MONUMENT RIDGE EAST FILING NO. 1
WATER, SANITARY SEWER, AND SANITARY SEWER FORCE MAIN
PLAN & PROFILES
EL PASO COUNTY, COLORADO

MONUMENT RIDGE EAST
FILING NO. 1
UTILITY CONSTRUCTION DRAWINGS

V5_UT CDs.pdf Markup Summary

DESIGNED BY:	MGP	DRAWN BY:	MGP
SCALE:	1" = 50'	DATE:	04/28/25
JOB NUMBER	24-001	SHEET	4 OF 12

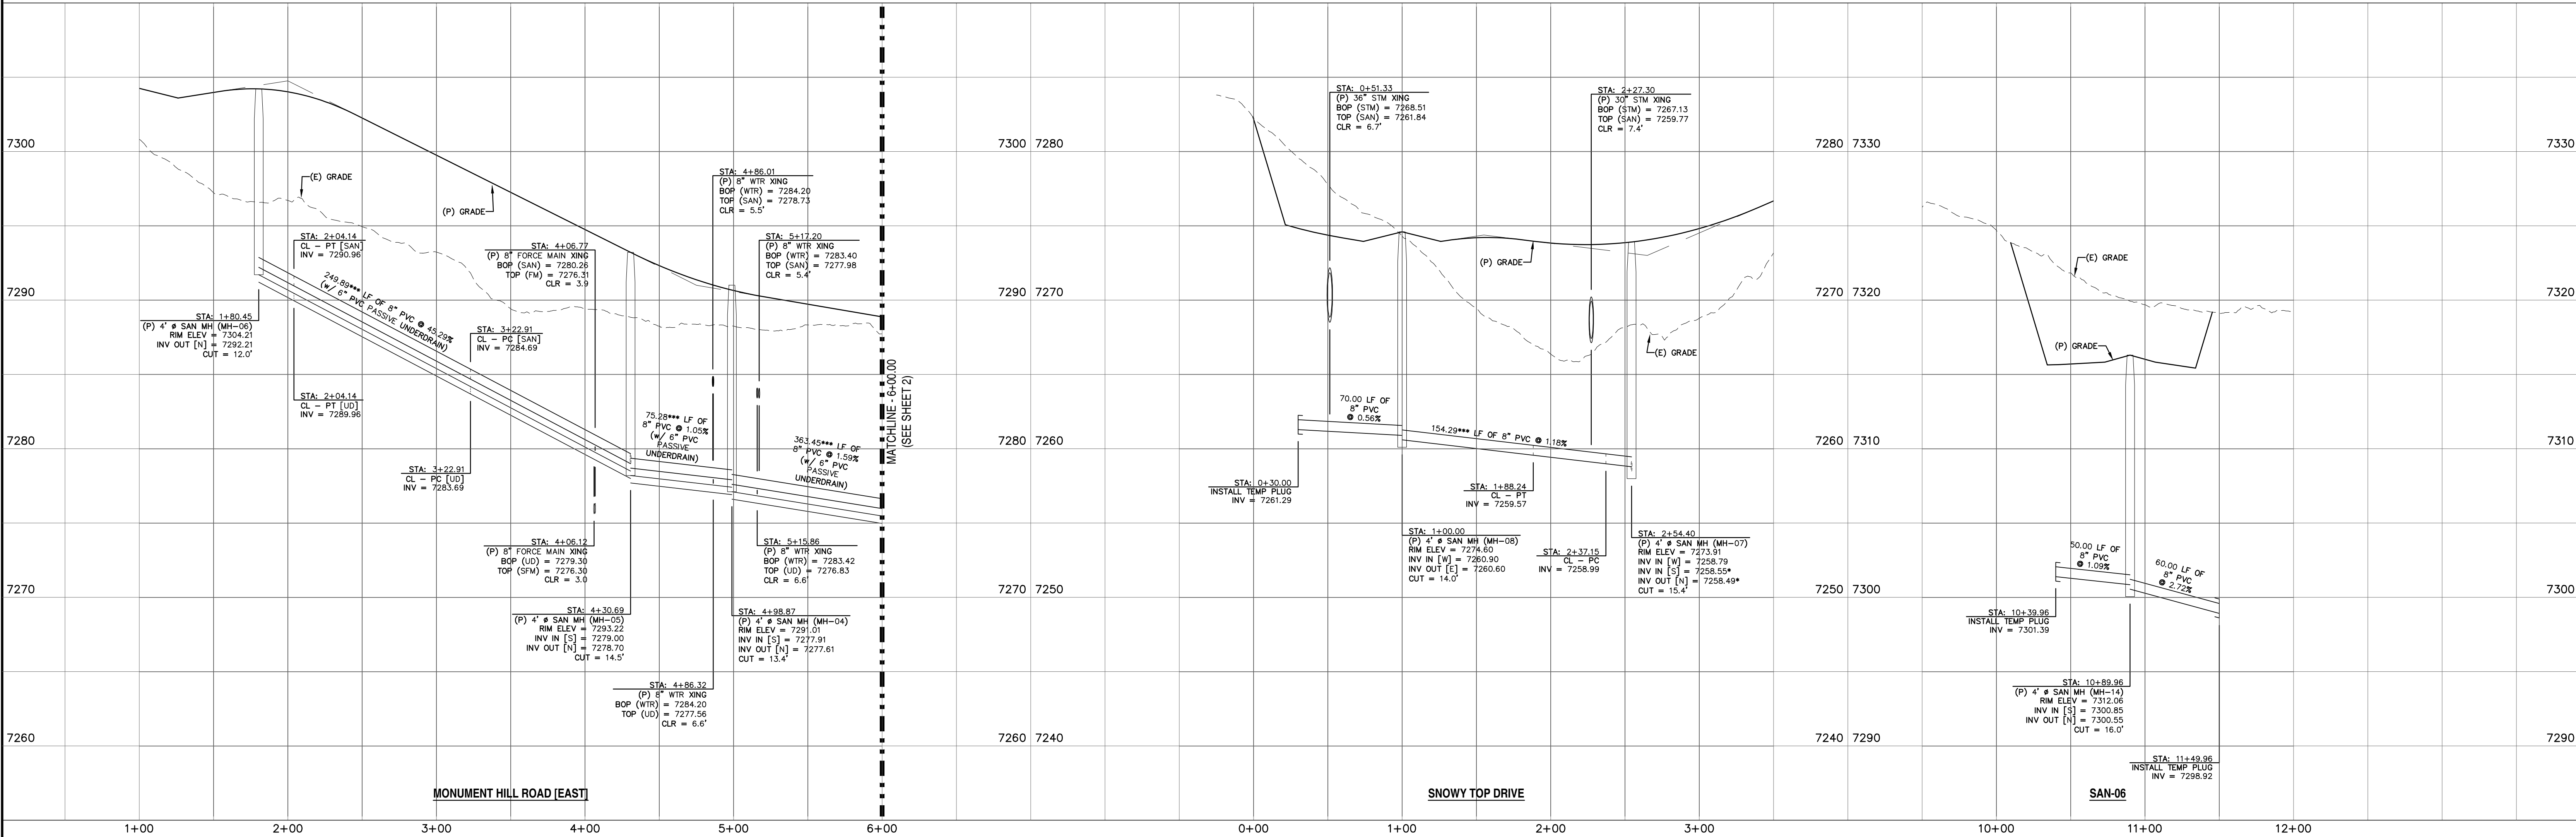
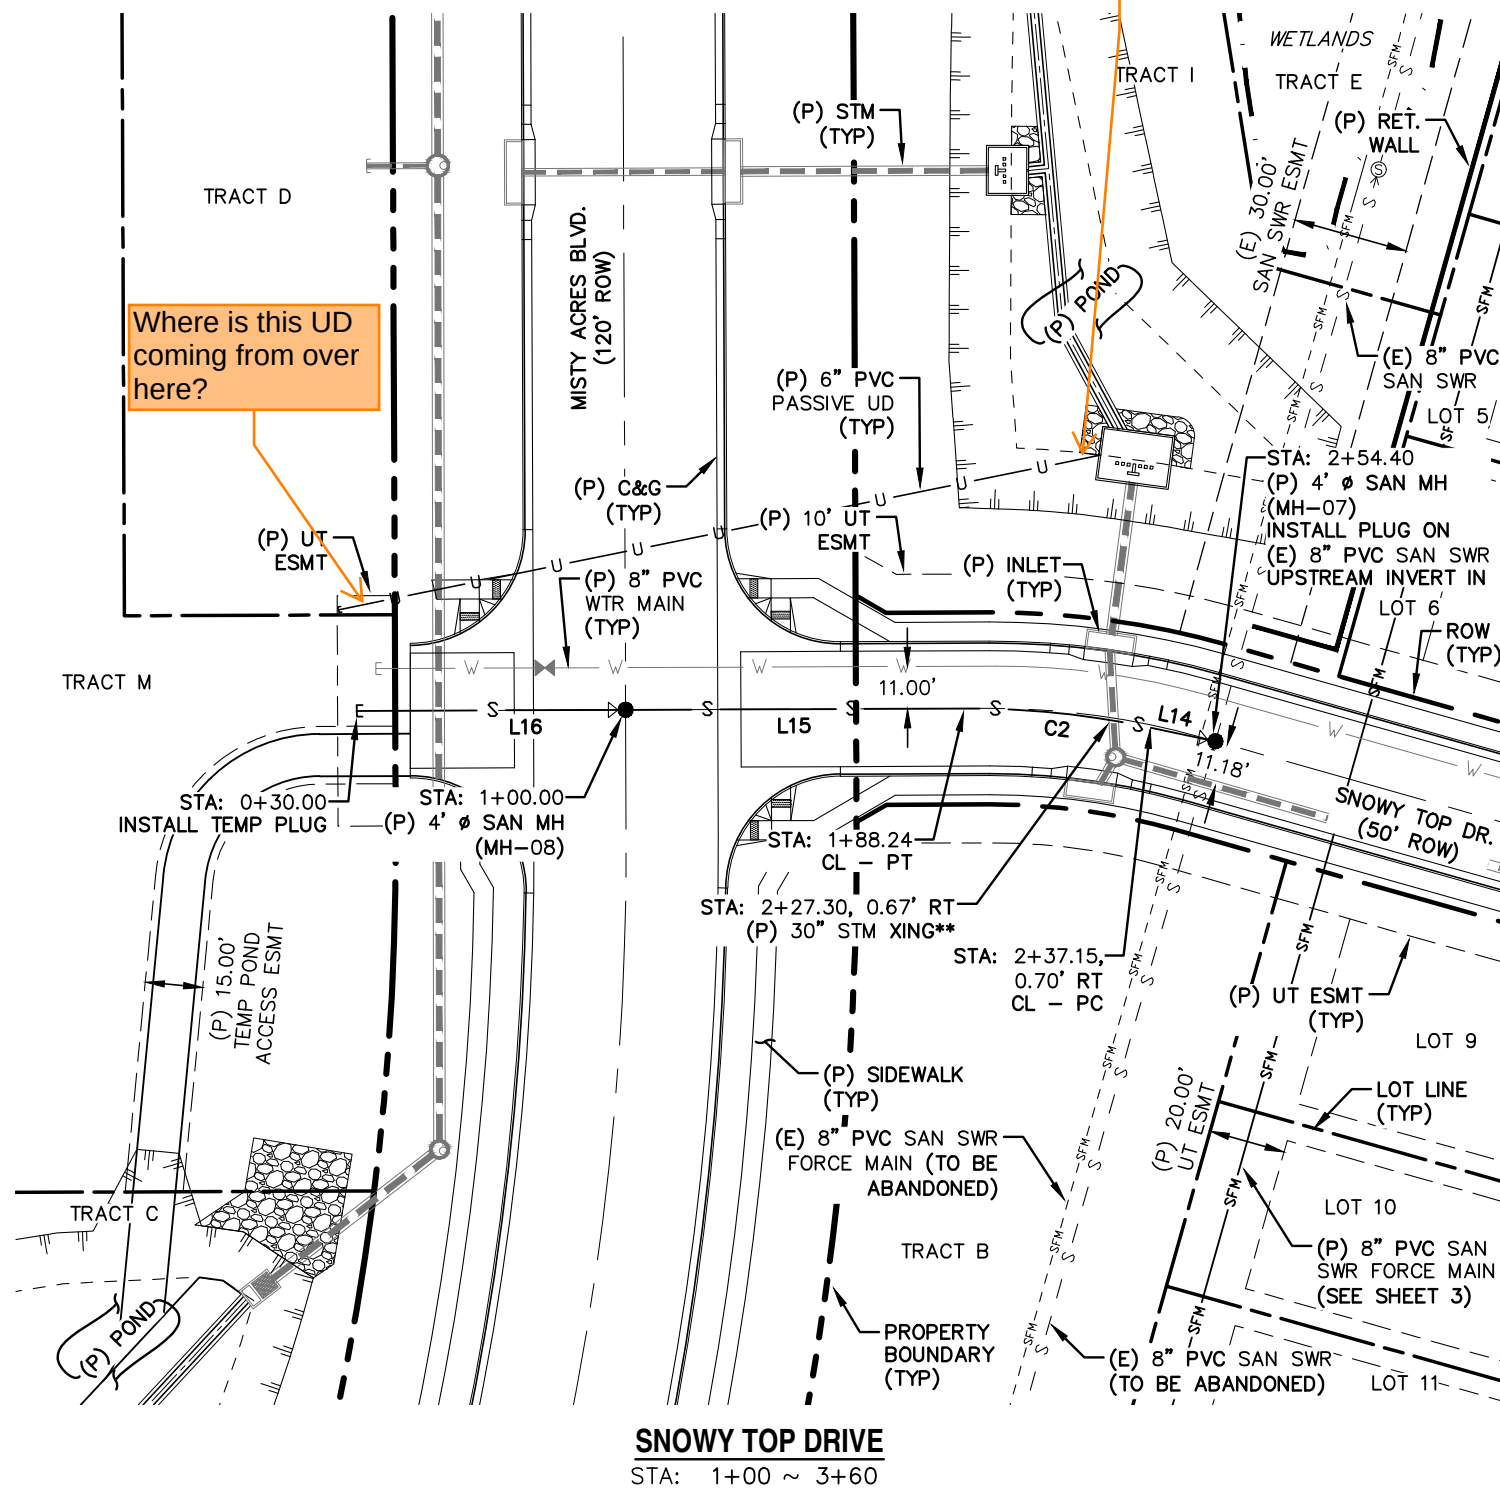
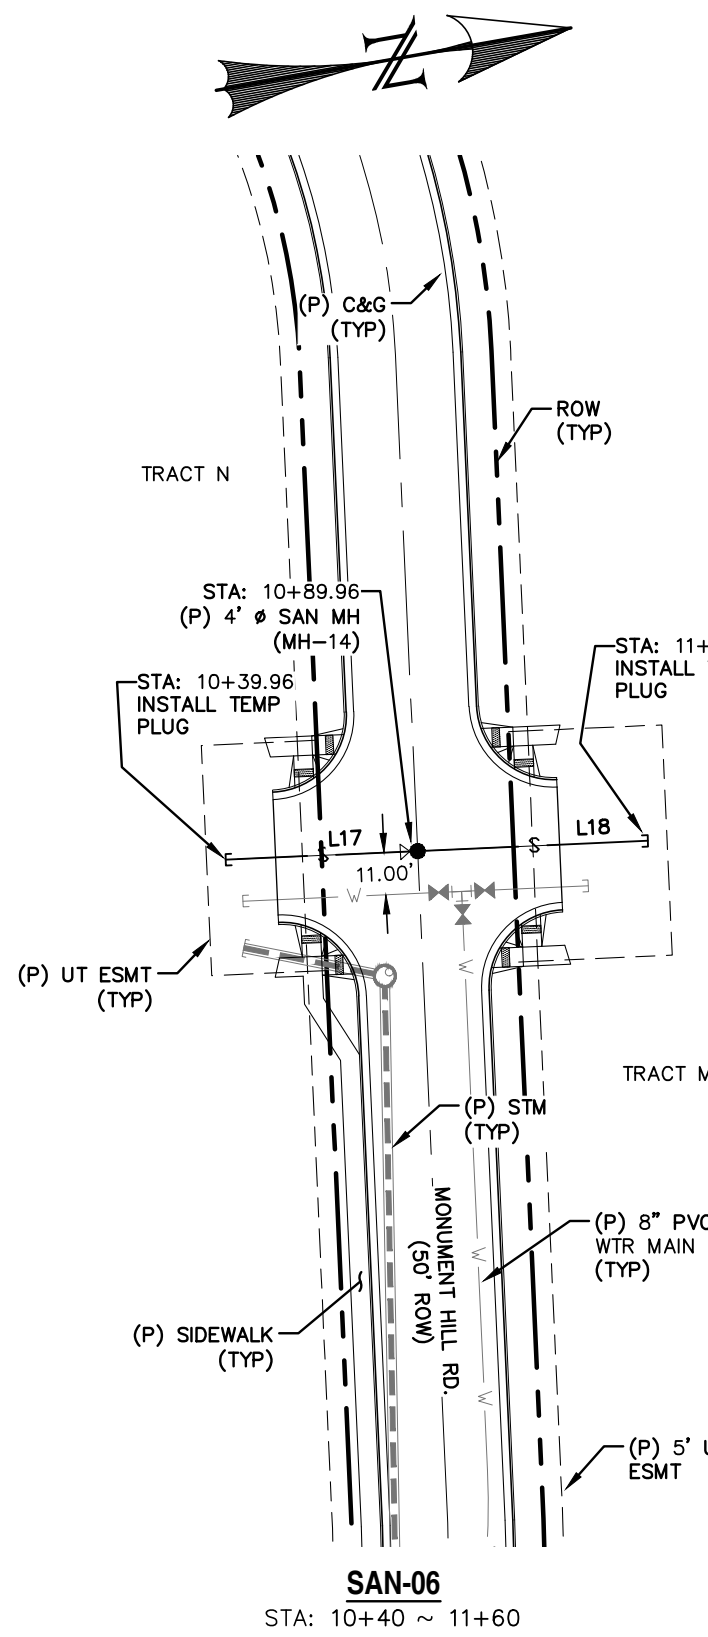
The pond has not been sized for the flows from this underdrain. MHFD recommends all GW/underdrain flows be routed to past the outlet structure (or within the outlet structure, just past the orifice plate)

Where is this UD coming from over here?

The pond has not been sized for the flows from this underdrain. MHFD recommends all GW/underdrain flows be routed to past the outlet structure (or within the outlet structure, just past the orifice plate)

DESIGNED BY: MGP
SCALE: 1" = 50'
JOB NUMBER: 24-001
DRAWN BY: MGP
DATE: 04/28/25
SHEET: 6 OF 12

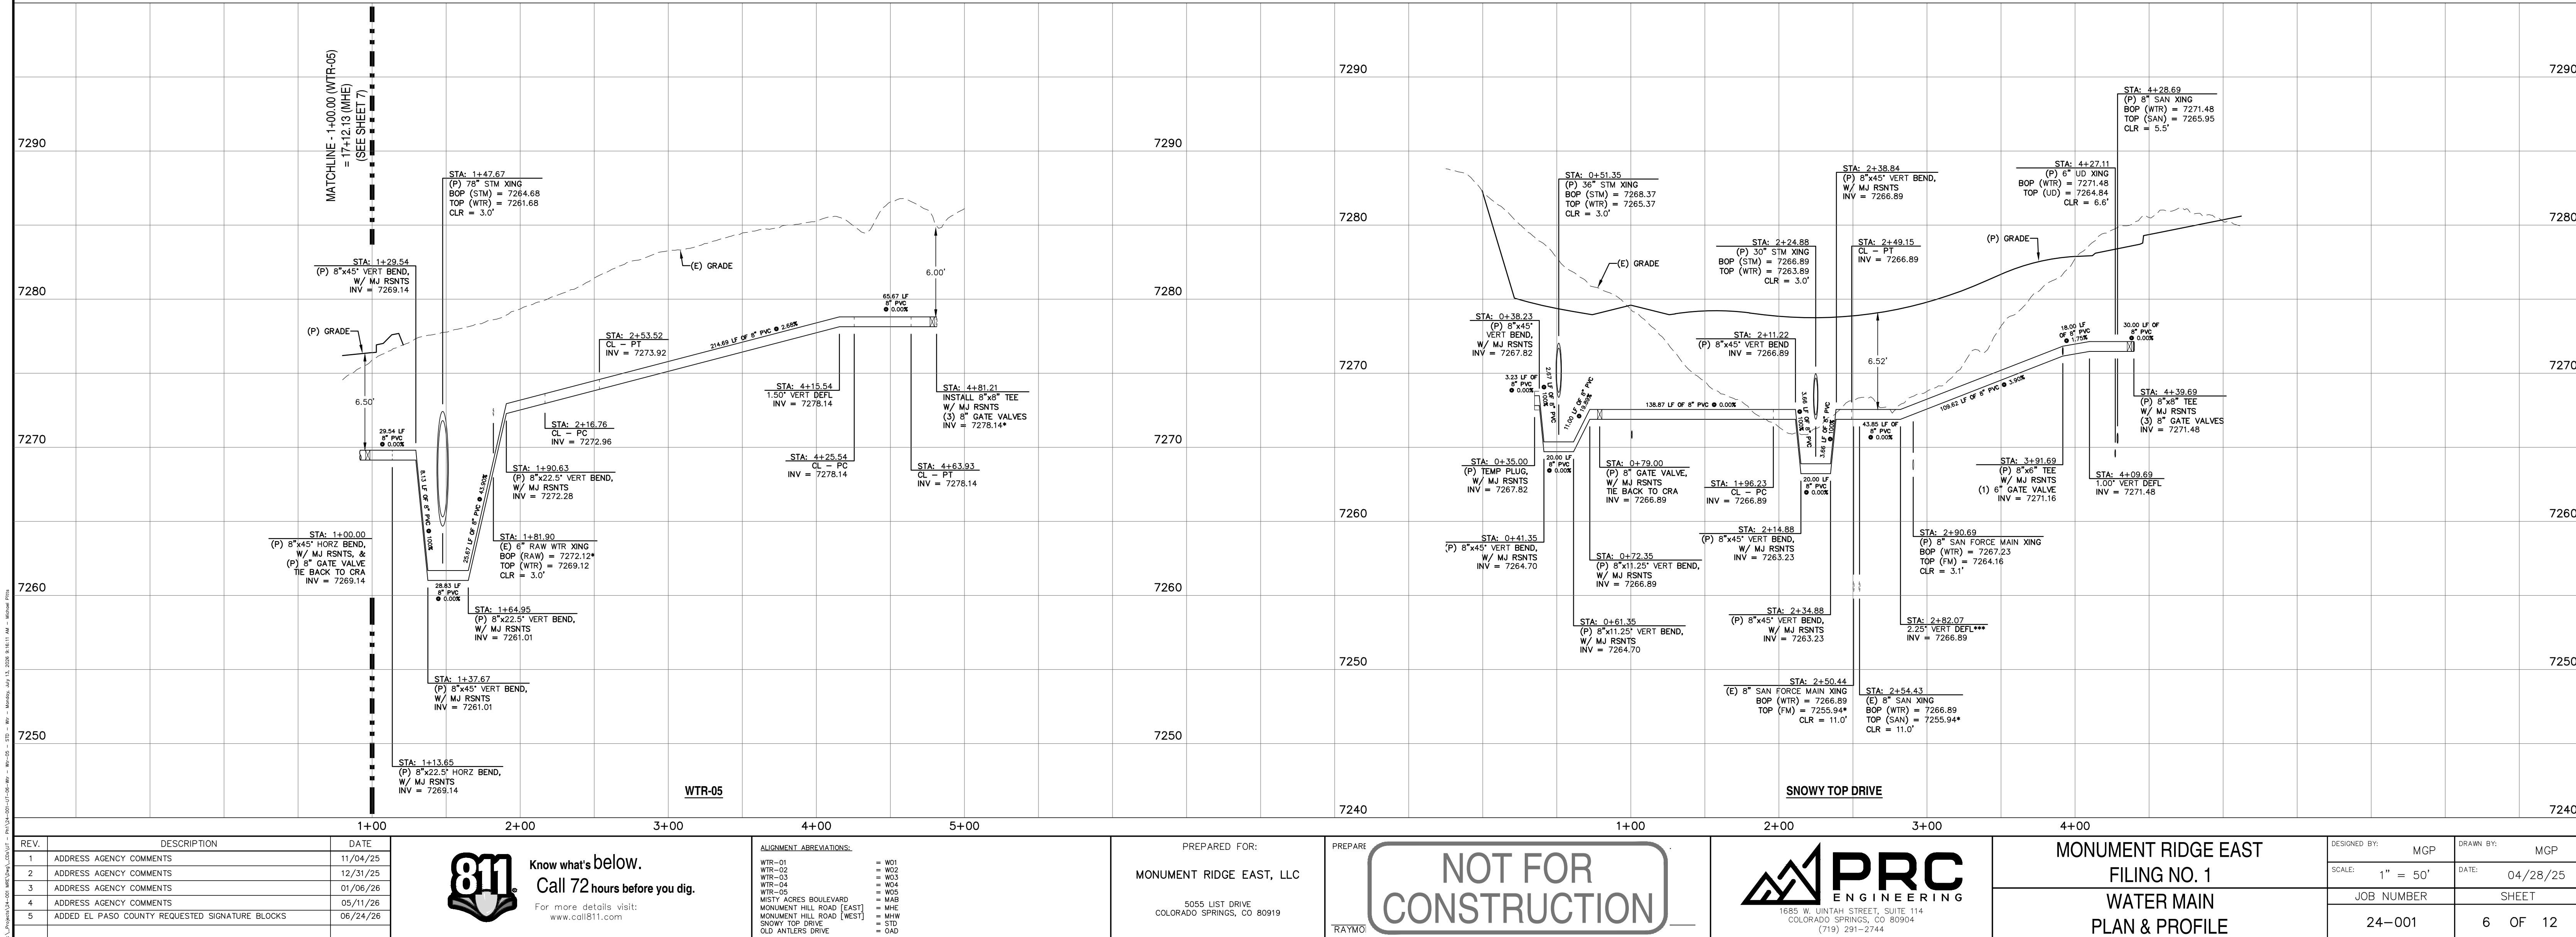
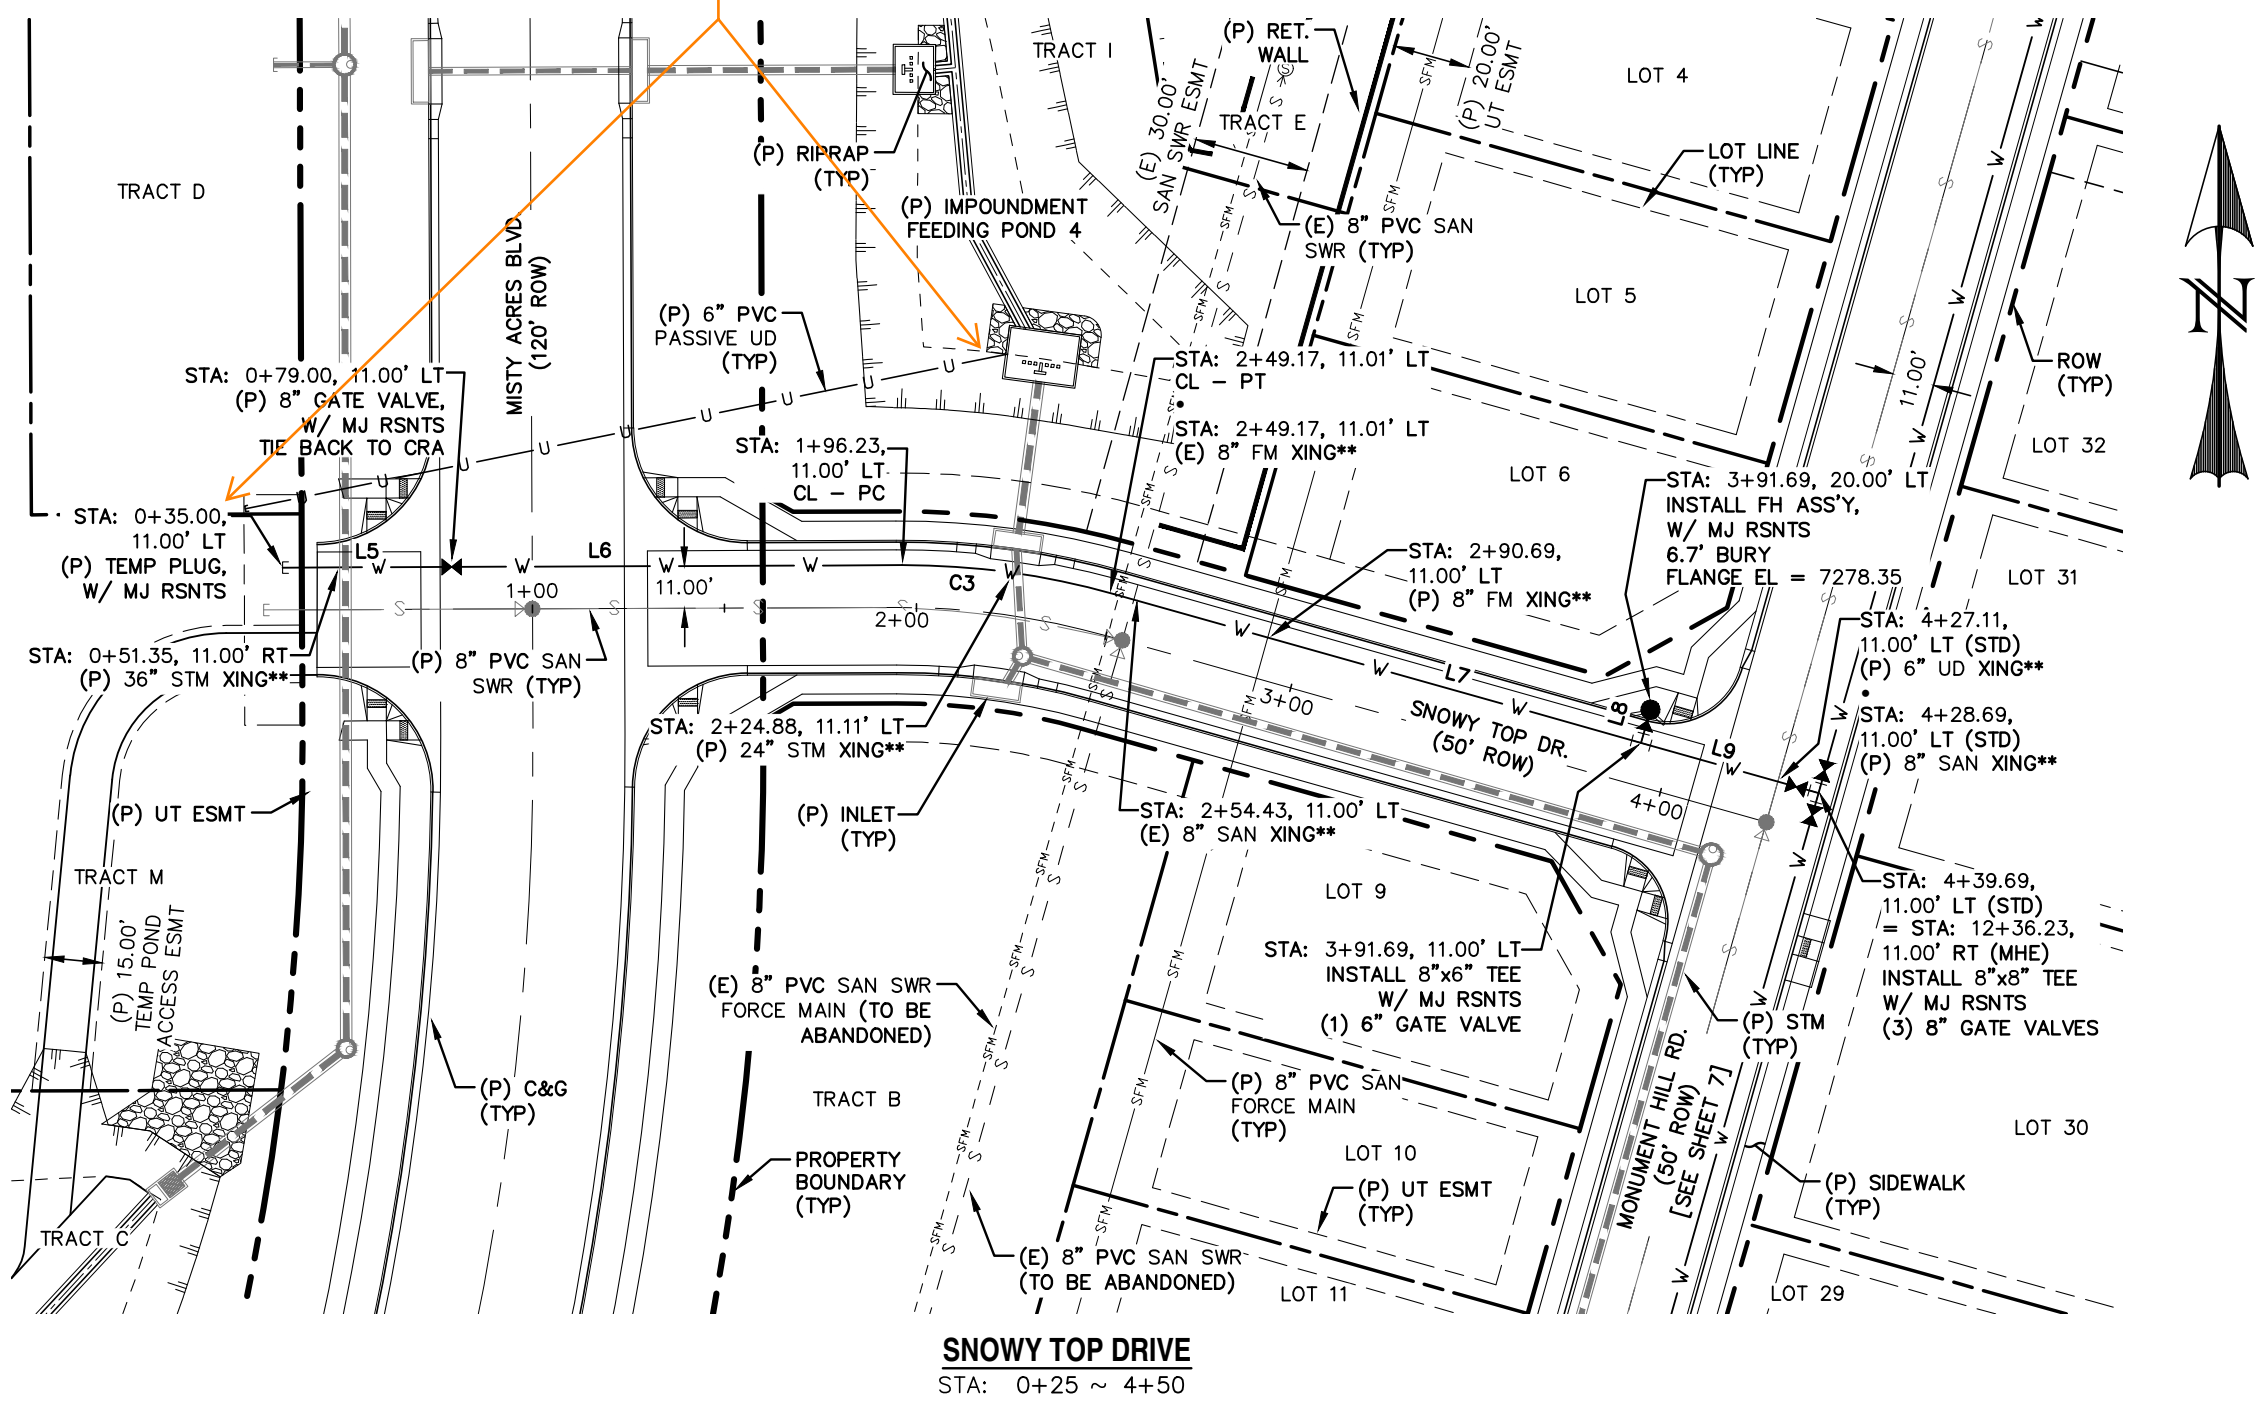
same comments/questions about the UD as on page 4 above (since this is the same pipe/pond)

same comments/questions about the UD as on page 4 above (since this is the same pipe/pond)
